# Centennial Park Accessibility Report/ Onsite Review 6-8-19

Chassell Township requested a formal site review of their premier Centennial Park along the shoreline of Lake Superior. SAIL had earlier in the year supported the Township's efforts to have their updated five year Parks and Recreation Plan accepted by the Michigan Department of Natural Resources (DNR). At that time, SAIL recommended the Township consider a formal site review of Centennial Park for ADA compliance. Lynn Gierke, the Township Clerk managed arrangements for a formal site review in June after the Township voted to pay for a site review conducted by the Superior Alliance for Independent Living, a member of the Disability Network of Michigan(SAIL) to evaluate the site, and report the findings.

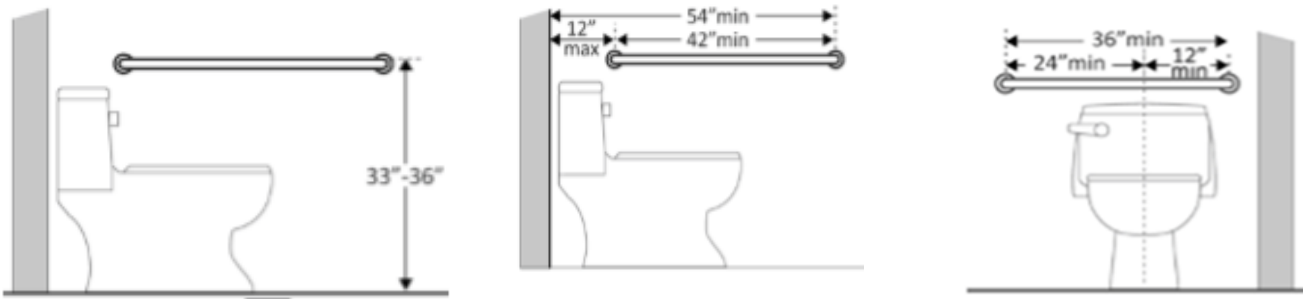
**IV. Accessible Egress from the Pavilion:** We moved to exiting the Pavilion building and found that the route to leave the building on the pathway to the playground and fishing pier was raised above the  $\frac{3}{4}$  inch allowed. To become compliant will be a **Level I modification**.

It is not an option to leave by the door on this side of the Pavilion near the Playground parking lot due to the step down from the door. This could be remediated with a simple ramp to achieve the threshold of a maximum of  $\frac{3}{4}$  an inch and a slope of no more than 1:20 inches. This is also a **Level 1 modification**.
